CONSTRUCTION INFRASTRUCTURE DRAWINGS CID-24-04		01	02	03	04	REVISIONS		DATE
TOWN OF ROLESVILLE CID-24-04 V2		01	02	03	04			
TOWN OF ROLESVILLE CID-24-04 V3								
TOWN OF ROLESVILLE CID-24-04 V4								
TOWN OF ROLESVILLE CID-24-04 V5								
TOWN OF ROLESVILLE CID-24-04 V6								
TOWN OF ROLESVILLE CID-24-04 V7								
TOWN OF ROLESVILLE CID-24-04 V8								
TOWN OF ROLESVILLE CID-24-04 V9								
TOWN OF ROLESVILLE CID-24-04 V10								
TOWN OF ROLESVILLE CID-24-04 V11								
TOWN OF ROLESVILLE CID-24-04 V12								
TOWN OF ROLESVILLE CID-24-04 V13								
TOWN OF ROLESVILLE CID-24-04 V14								
TOWN OF ROLESVILLE CID-24-04 V15								
TOWN OF ROLESVILLE CID-24-04 V16								
TOWN OF ROLESVILLE CID-24-04 V17								
TOWN OF ROLESVILLE CID-24-04 V18								
TOWN OF ROLESVILLE CID-24-04 V19								
TOWN OF ROLESVILLE CID-24-04 V20								
TOWN OF ROLESVILLE CID-24-04 V21								
TOWN OF ROLESVILLE CID-24-04 V22

RESERVE @ MITCHELL MILL
TOWN OF ROLESVILLE, WAKE COUNTY, NORTH CAROLINA
CONSTRUCTION PLANS
EROSION CONTROL PLAN OVERALL
PHASE 1 - STAGE 2

STRONG ROCK ENGINEERING GROUP		STRONG ROCK ENGINEERING GROUP, PLLC COMPANY LICENSE # P-2166 305 CHURCH AT NORTH HILLS STREET, SUITE

PROPOSED LIGHTNING BOLT LANE -
PLAN & PROFILE

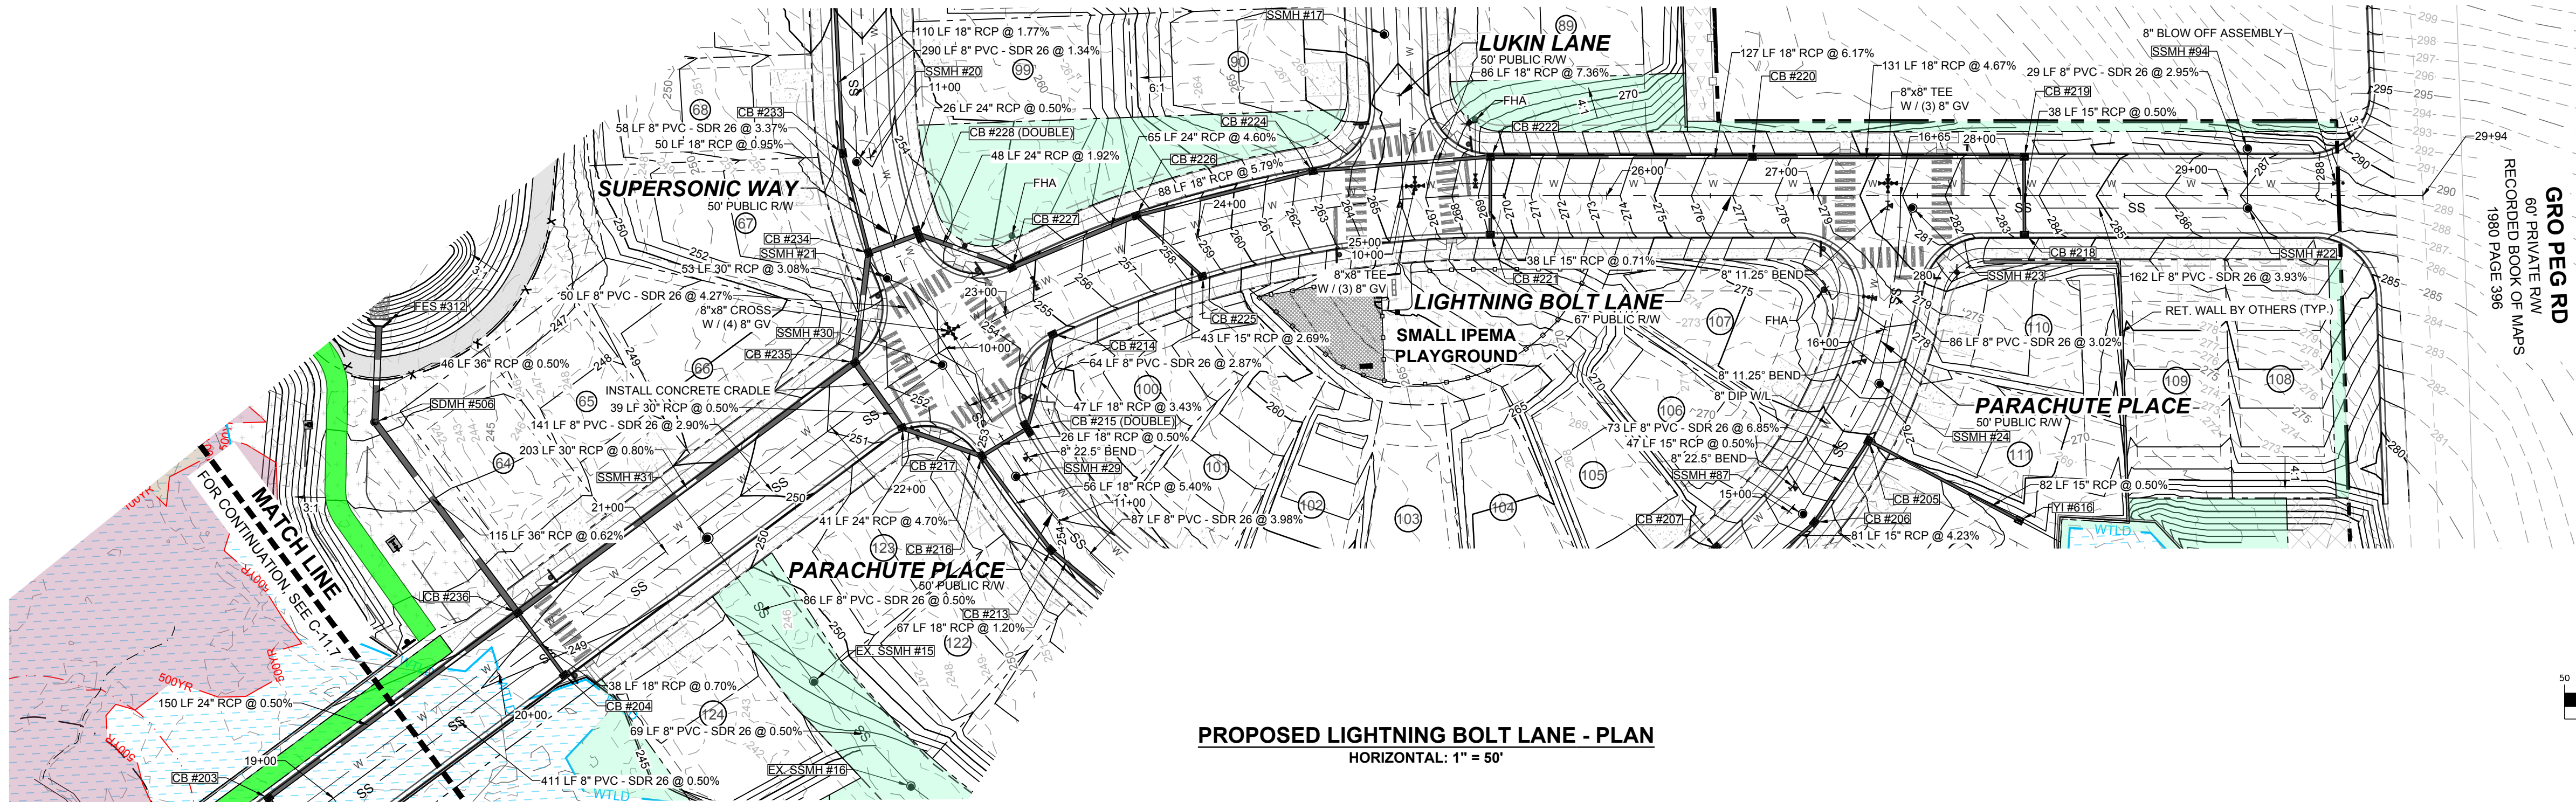
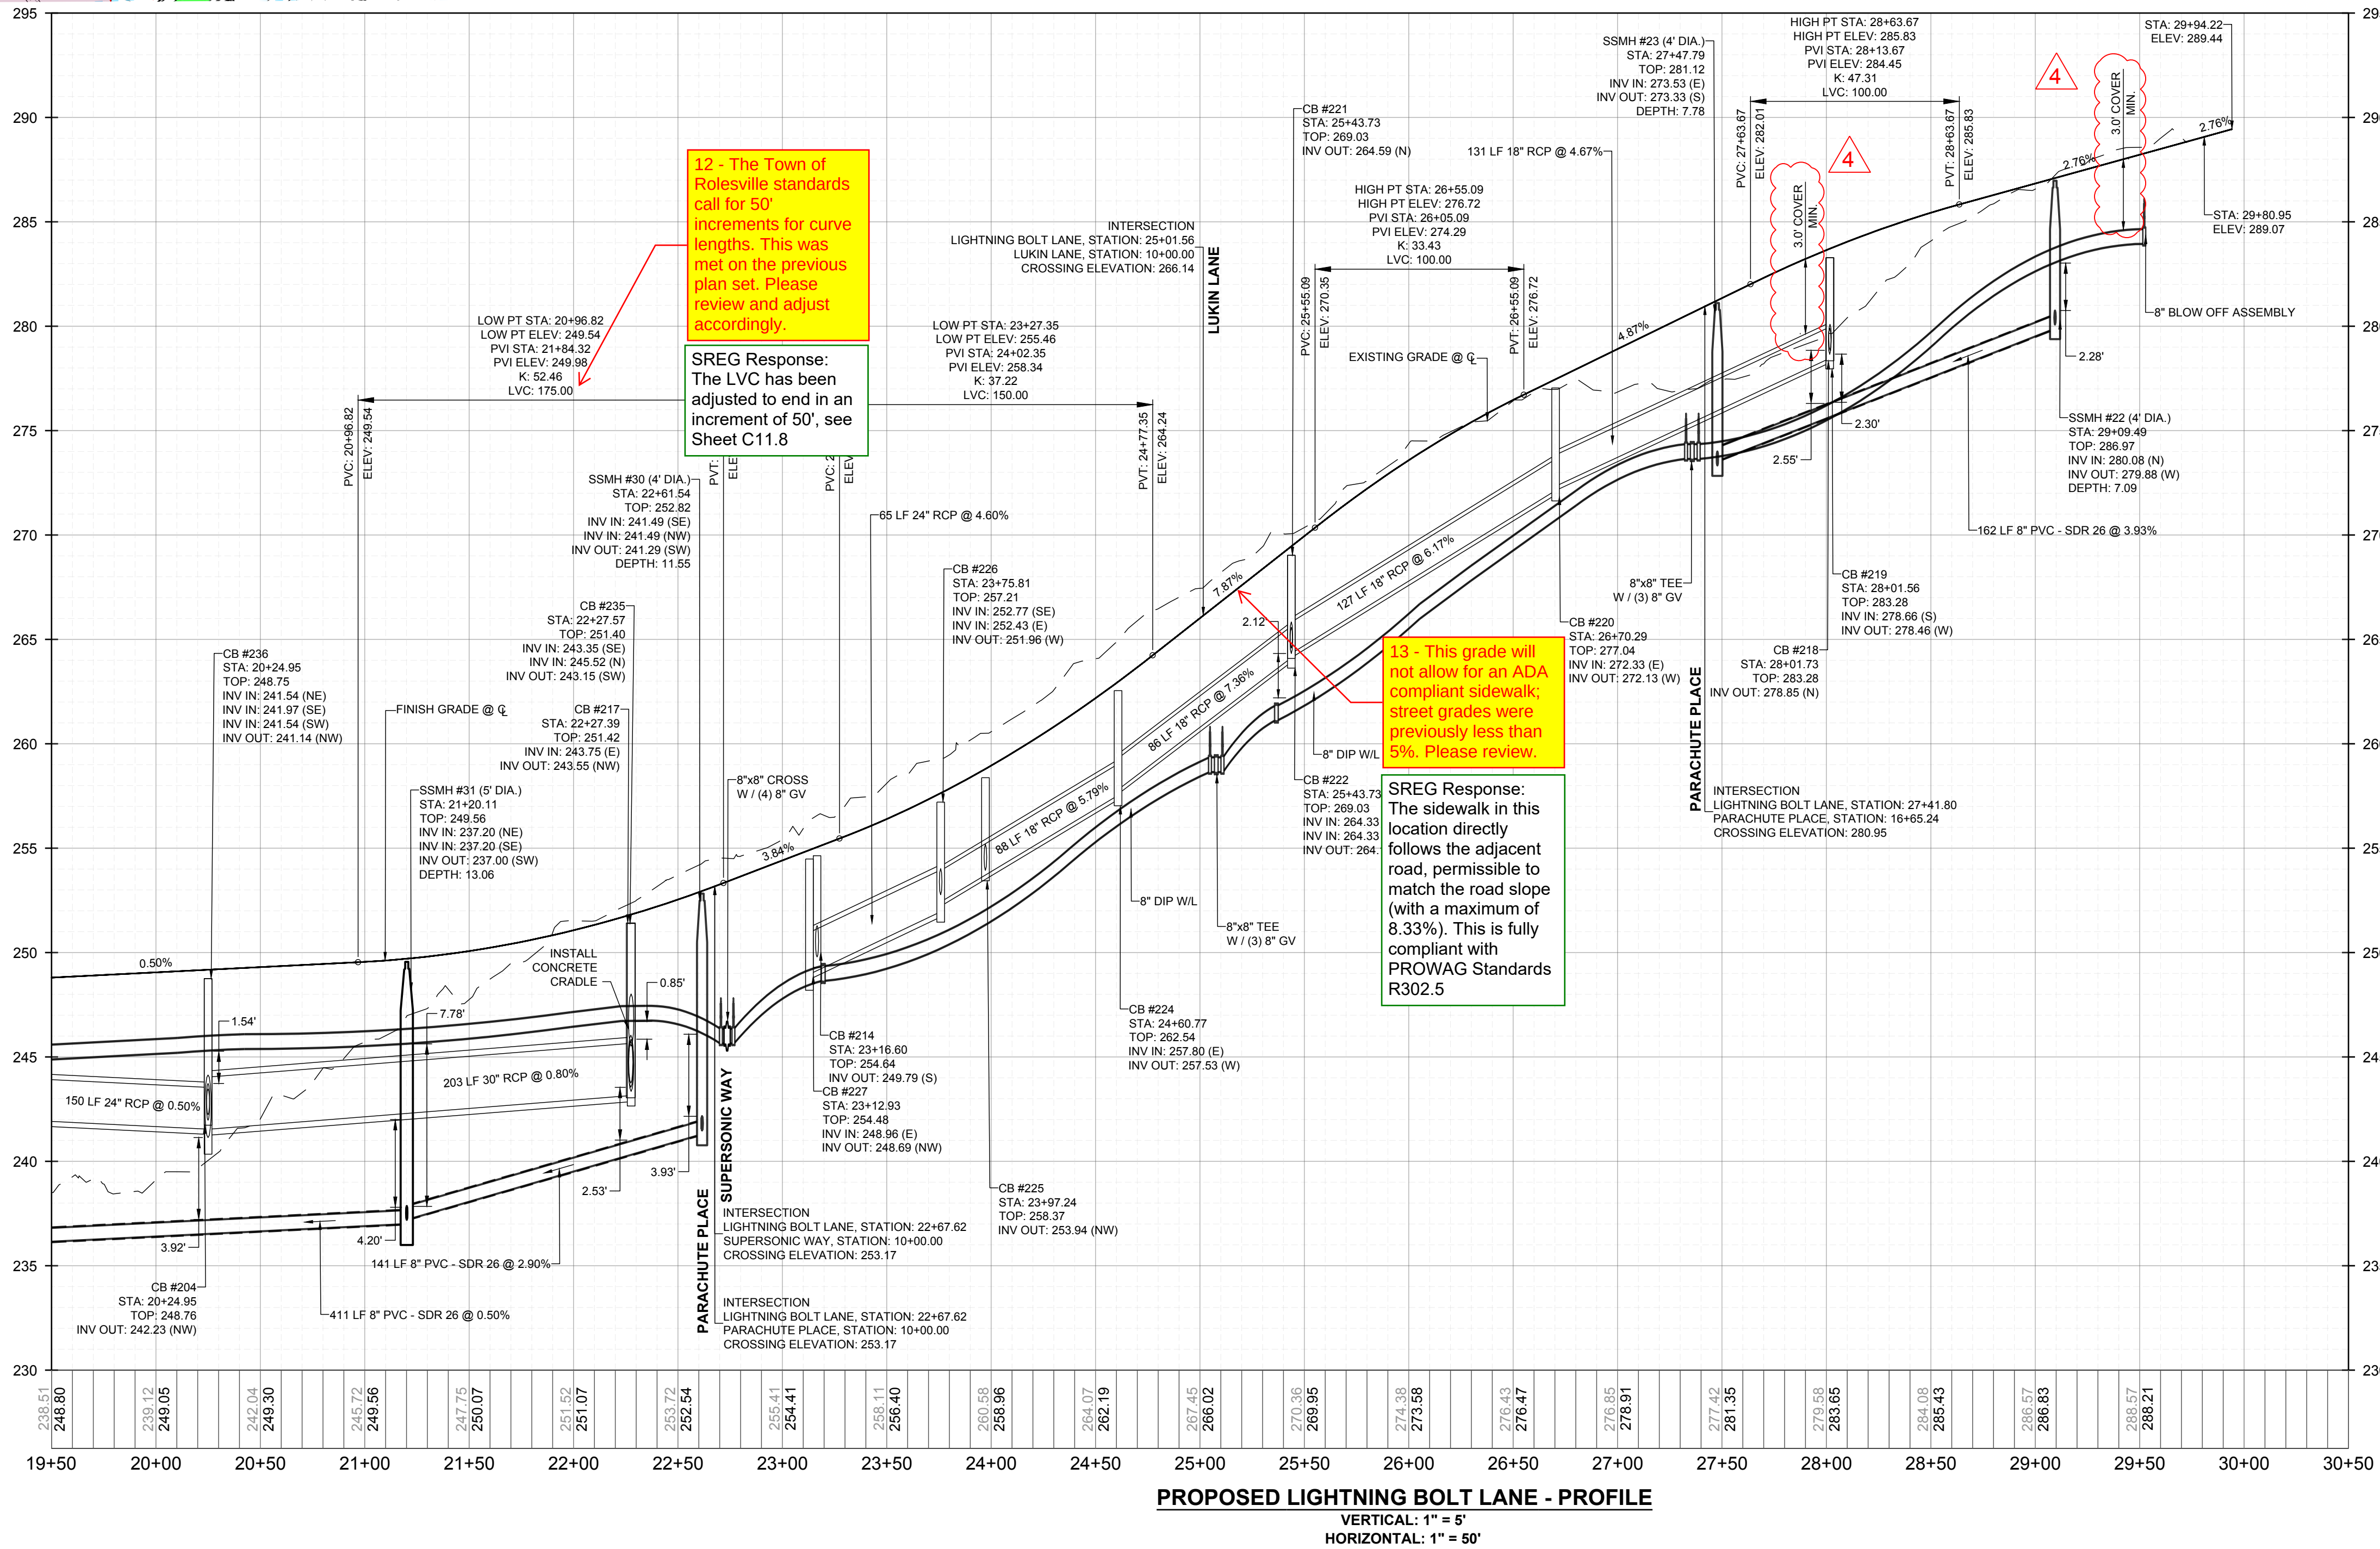
16 - A bridge is shown here, but is not indicated on the plan view on any sheets. Please show and label the bridge on all applicable sheets in plan view so it is easy to see and clear the extents.

15 - Show the culvert crossing

15 - Culvert crossing is missing. Please add back into view.

SREG Response:
The plans have been updated to show the proposed bridge crossing at this location. Please see Sheet C11.7 and the separately submitted bridge plans.

SREG Response:
The plans have been updated to show the proposed bridge crossing at this location. Please see Sheet C11.7 and the separately submitted bridge plans.

SREG Response:
The plans have been updated to show the proposed bridge crossing at this location. Please see Sheet C11.7 and the separately submitted bridge plans.
